Access Compliance Report

Public Rights-of-Way

(Pedestrian Signals)

Intersection ID: N/A	Main Street:	Cross Street: N/A	Location: N/A
ADA ID: 5B45FE8BE0EE	Signal Type: One Push Button-APS	Overall Compliance: No	Severity Score: BTN 1: N/A BTN 2: N/A No BTN: N/A
Codes/Mitigation Info/Possible Solution		Field Measurements/Component Compliance

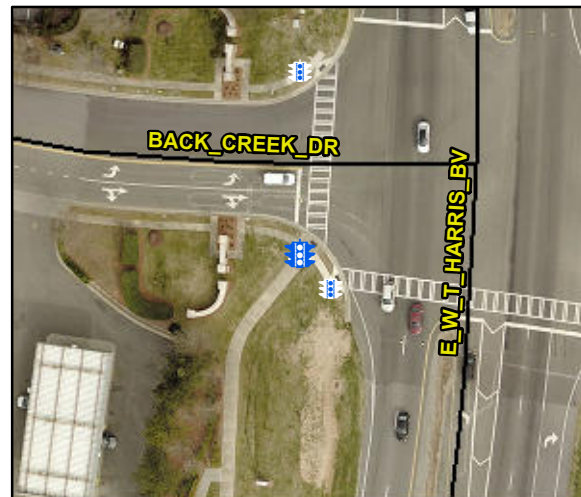
Possible Solutions: Replace Signal Push Button With APS Button on New Post. Remove & Replace Sign.

Surveyor Notes: TEXT HT 1/4, DIST BETWEEN ADDL BUTTON 293.0

PROW/ADA: R410.6, TMUTCD 4e.08, R404.2, R406.2, R209.1, MUTCD 4e.10
